**RADFORD UNIVERSITY
ALLEN BUILDING ELECTRICAL REPLACEMENT
PROJECT NUMBER 217-B5217-004**

**ADDEDNUM NO. 3
DECEMBER 10, 2025**

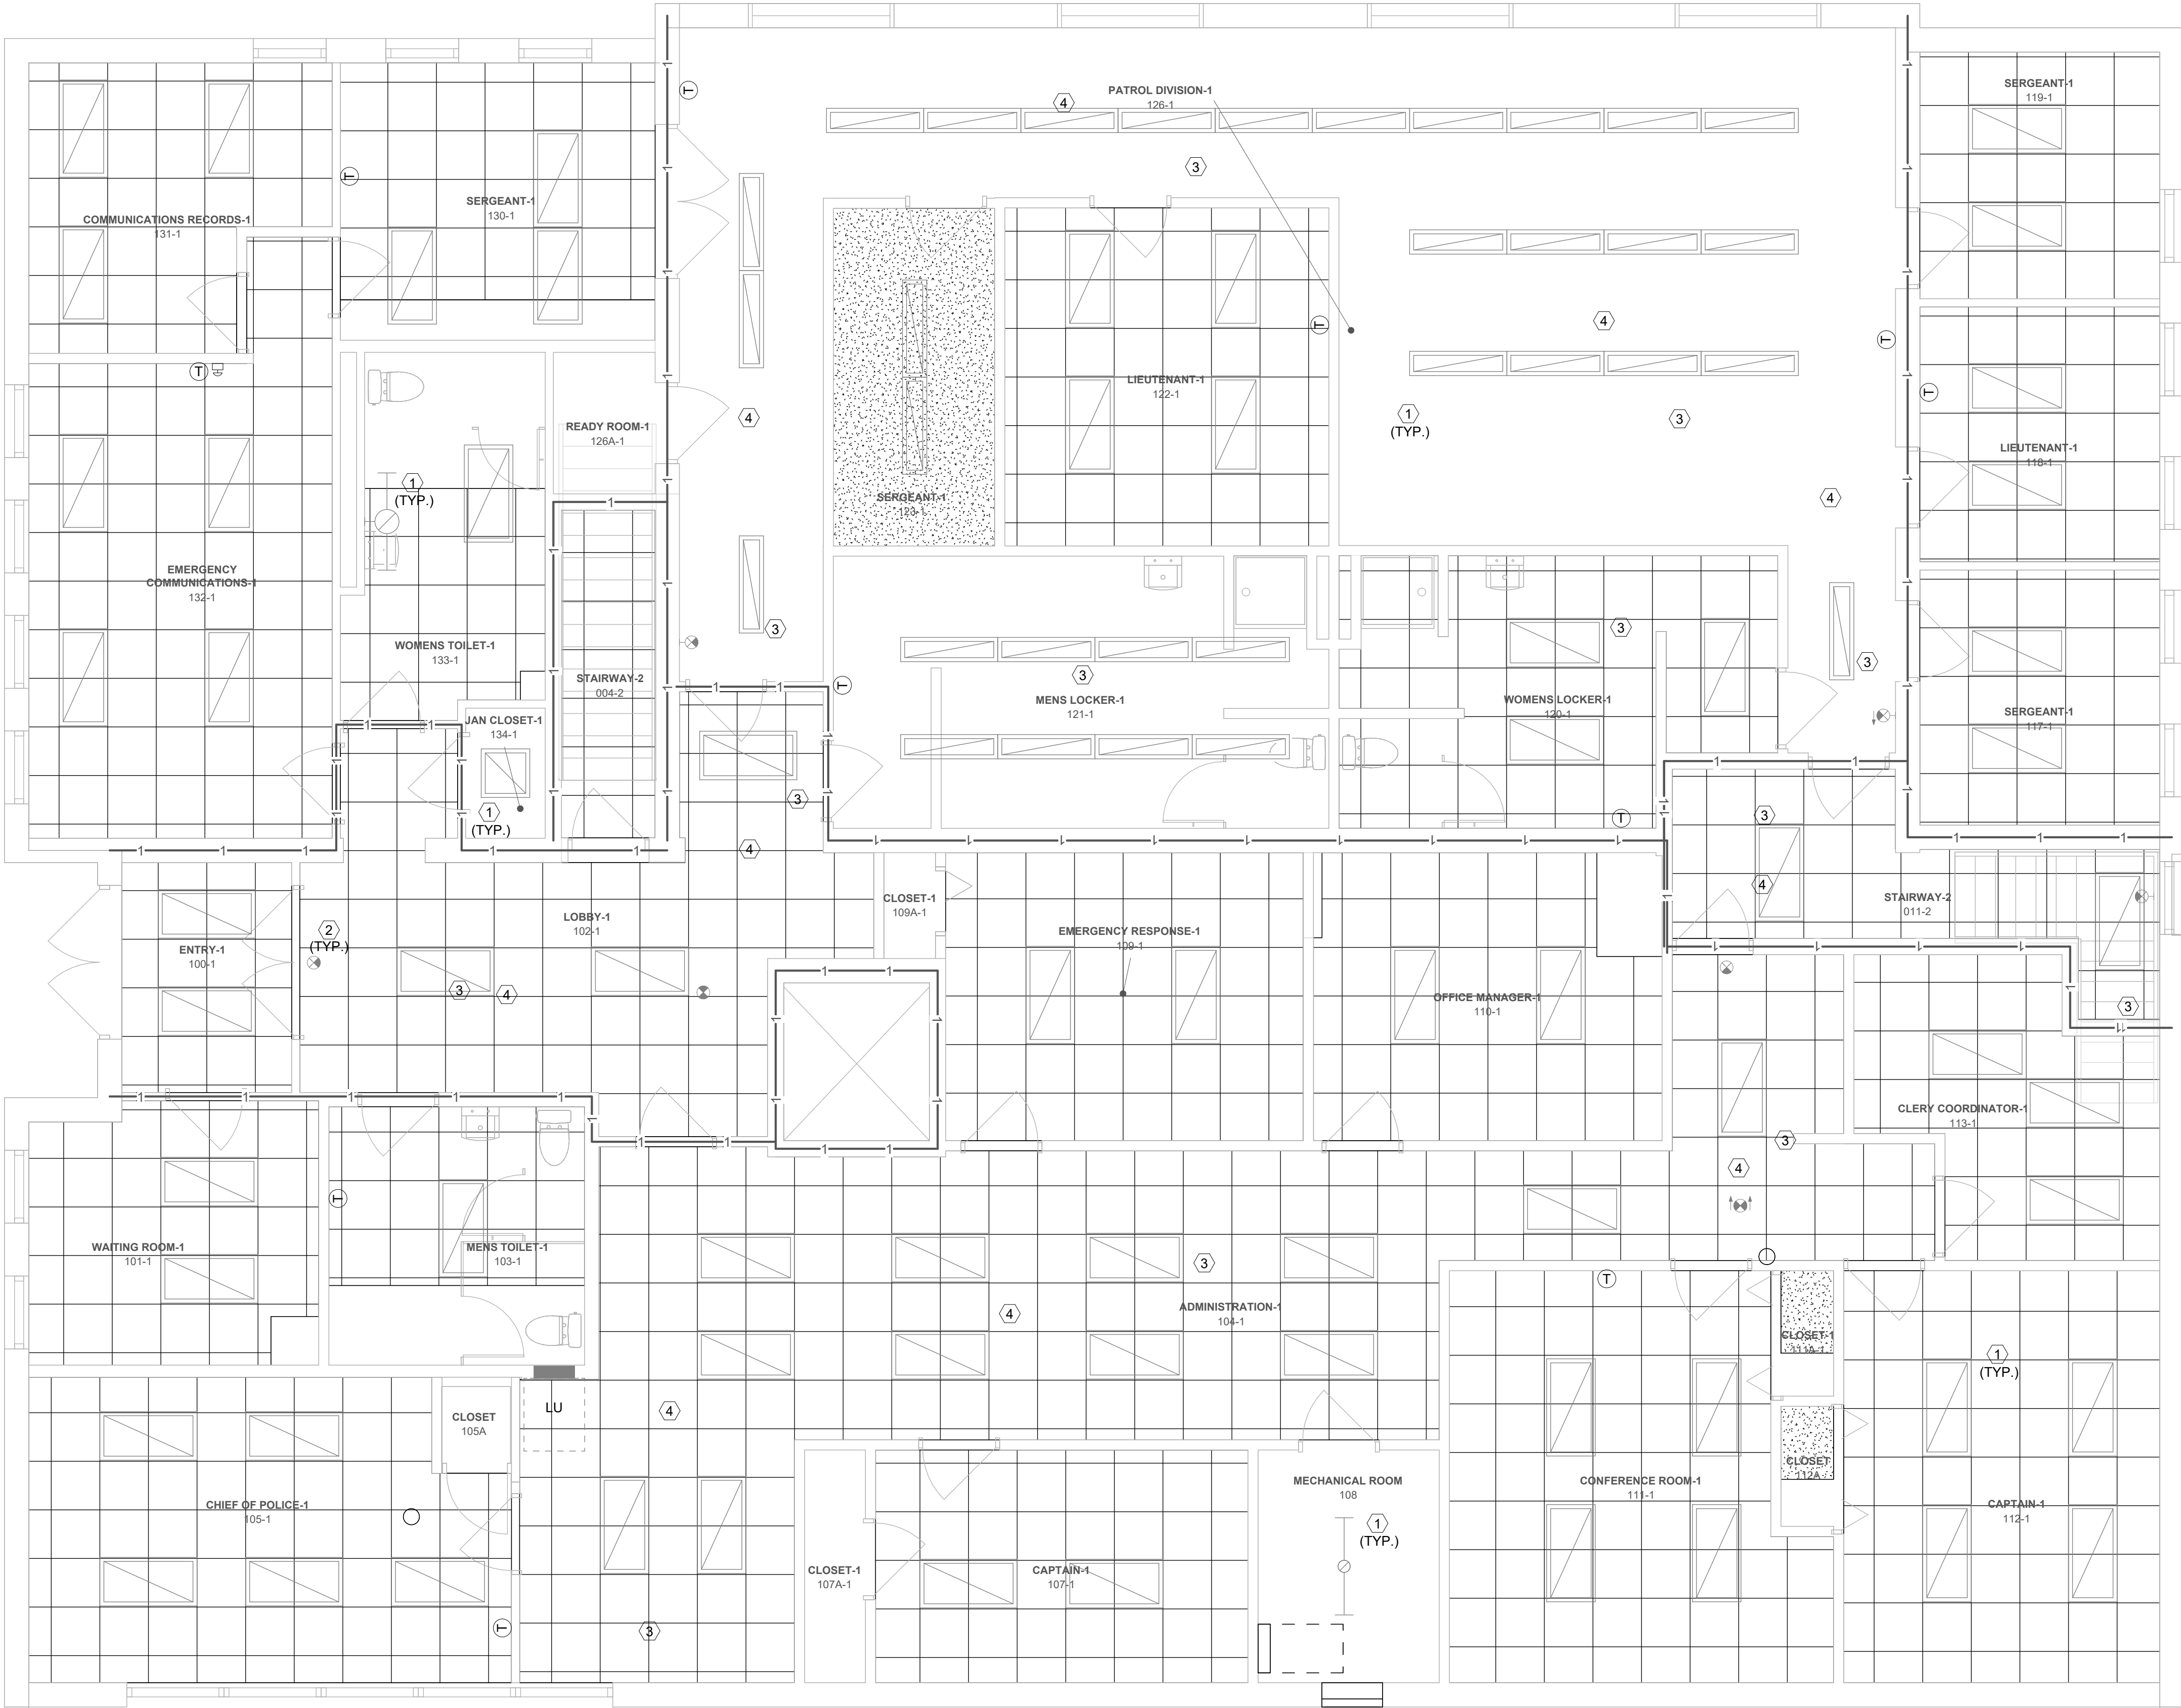
2. Drawing Sheet E1.21 - Notes 2&4 describe a junction box for a future duct detector for AHU-1. Note 2 has this Junction box on the roof and note 4 has the junction box above the ceiling. Which location requires the j box or does this AHU-1 require 2 boxes, 1 above the ceiling with the other j boxes on the plan, 1 on the roof.

Answer: The junction box shall be installed above the first floor accessible ceiling, just below the roof at the future AHU-1 location. The junction box is not at the rooftop. Note #2 will be modified for clarity in Addendum 3.
